Addendum #4

Date: 02/12/2024

Project: 2024 – Fishers Elementary School Addition & Renovations

PROJECT NO: 2021119 DATE: 02/12/2024 BY: Josh Cannaday

DRAWING NUMBER C601

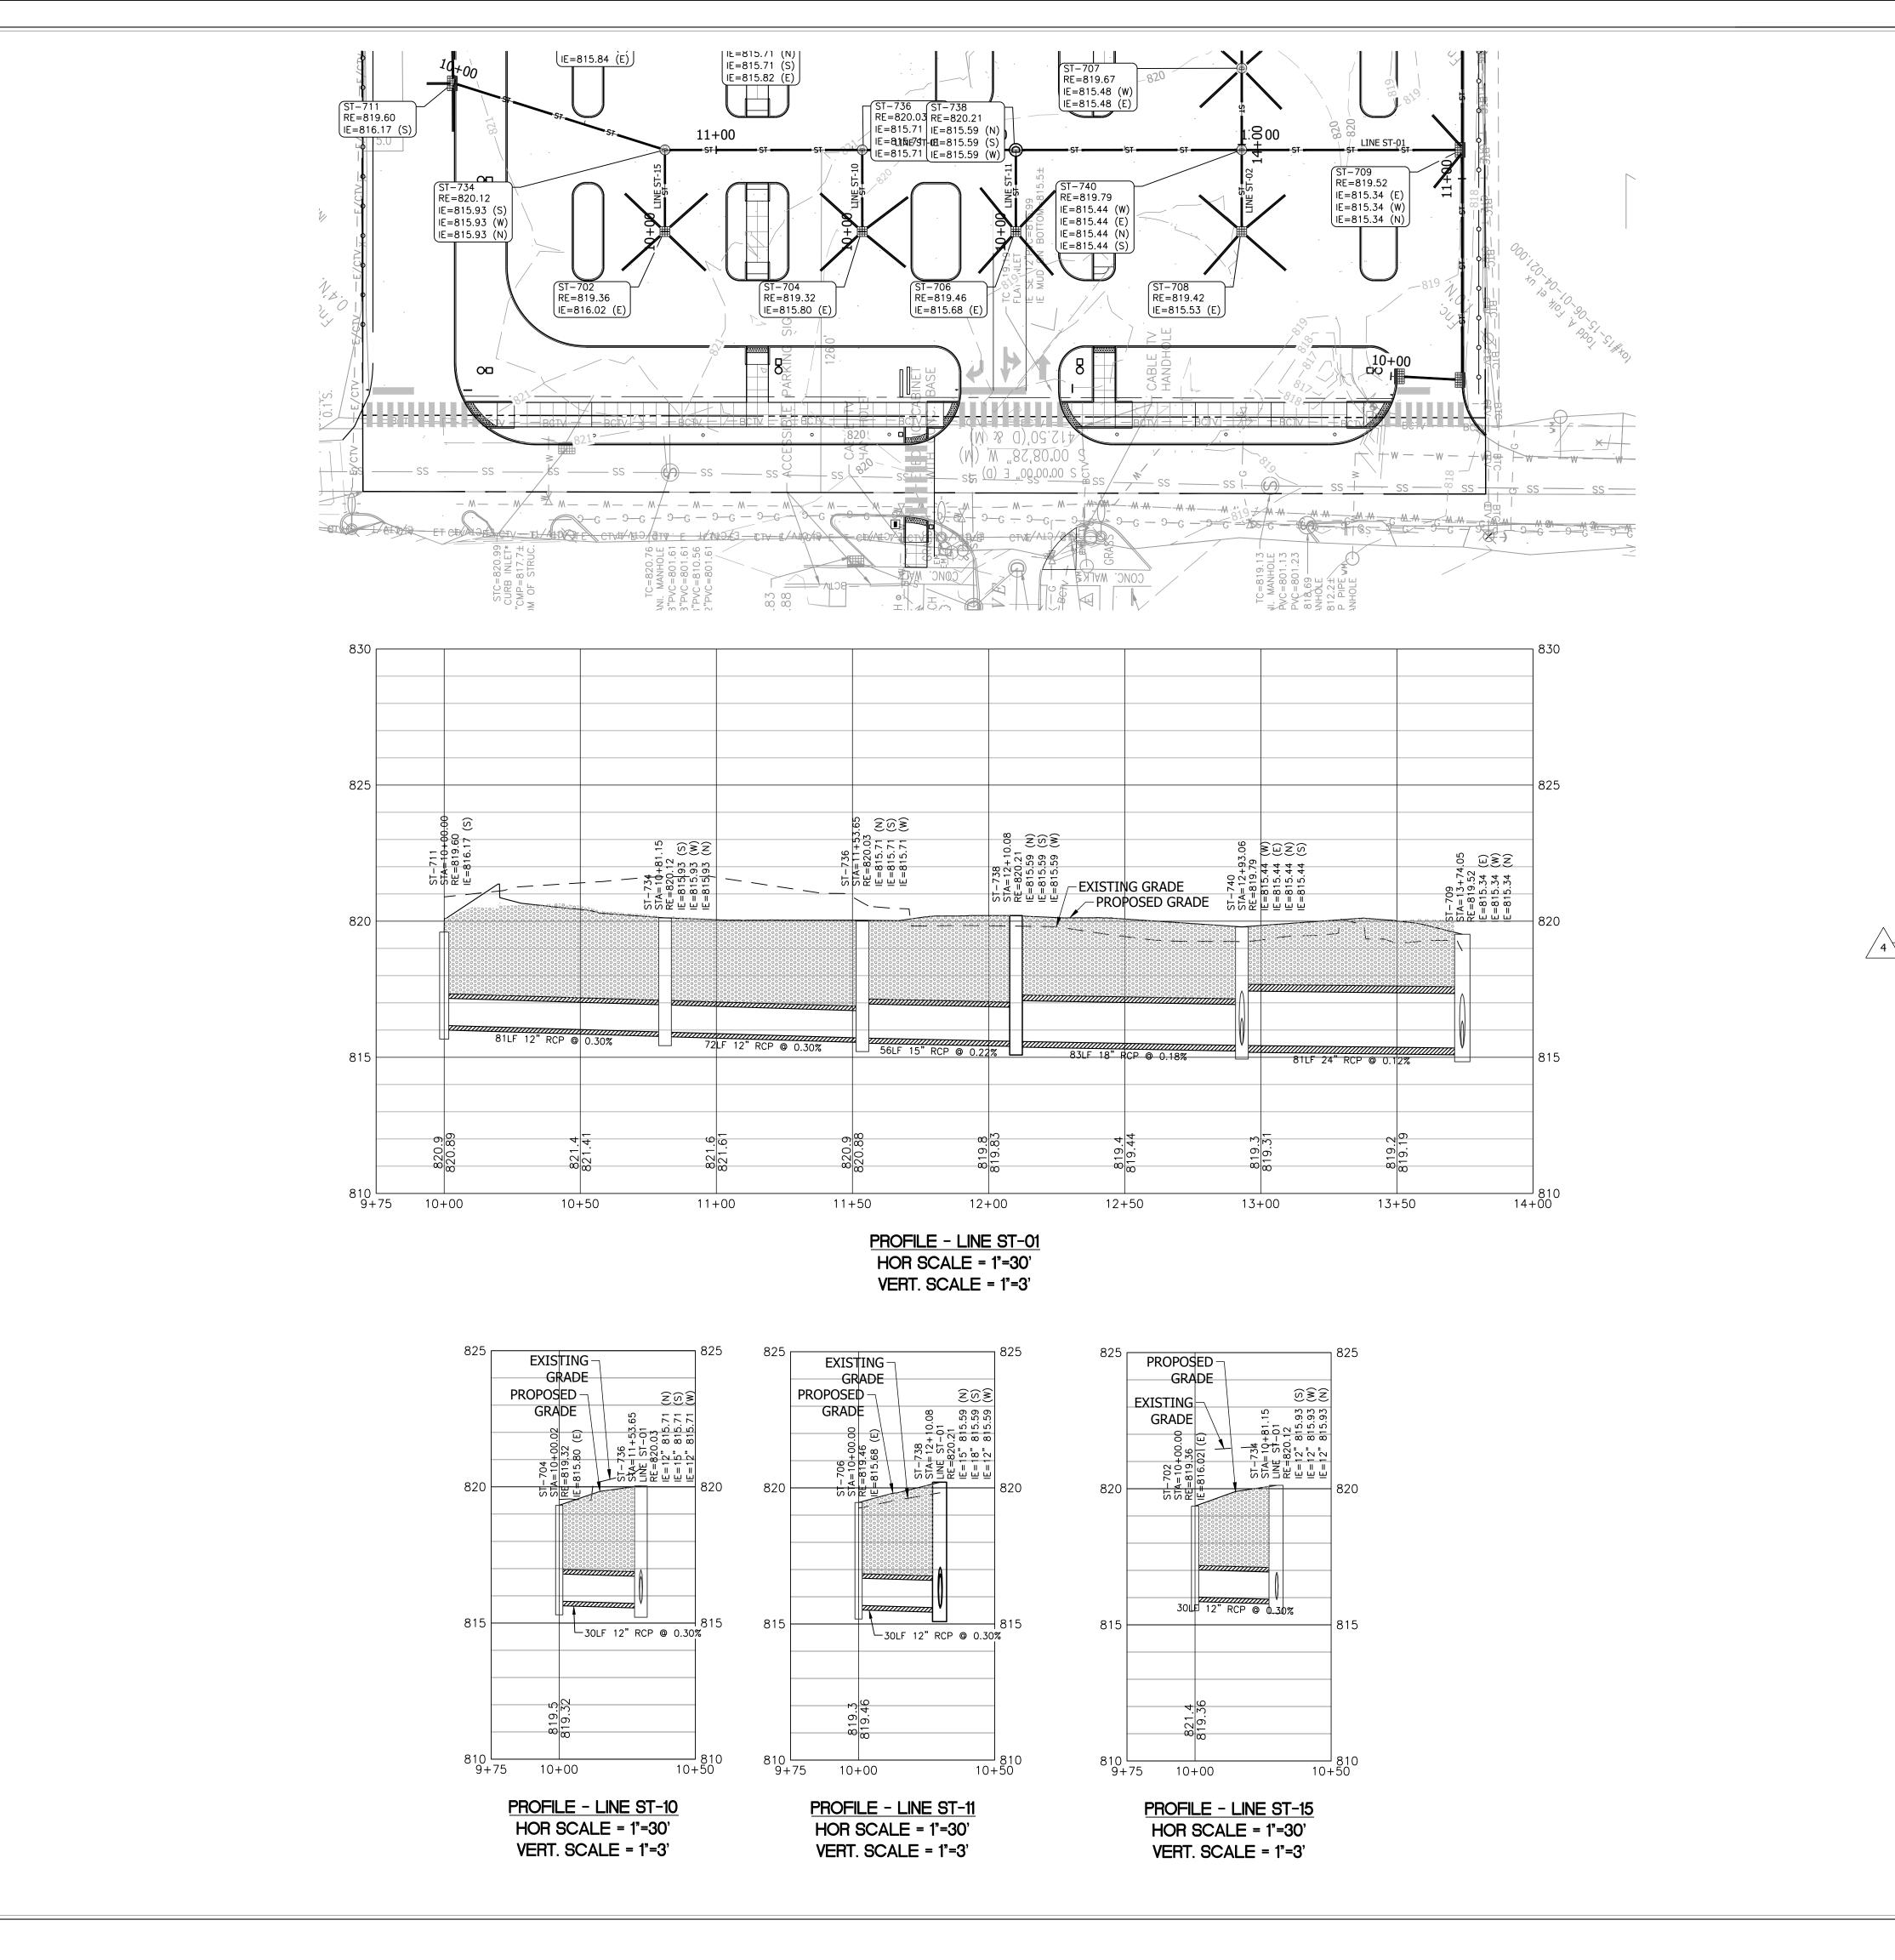
- 4.15 C601
  - A. Crosswalk and ADA ramp changes.
- 4.16 C701-C705
  - A. Note changes to refer to Fishers Details for Casting information.
- 4.17 C706
  - A. Updated Stormbrixx Detail.
- 4.18 C707
  - A. Updated detail information for diversion structures.
  - B. Removed SSD in lawn detail.
  - C. Removed conflicting diversion structure details.
- 4.19 C801
  - A. Sheet layout revision.
- 4.20 C901
  - A. General sheet update
- 4.21 C902-C930
  - A. Fishers Standard Details added to project titleblock
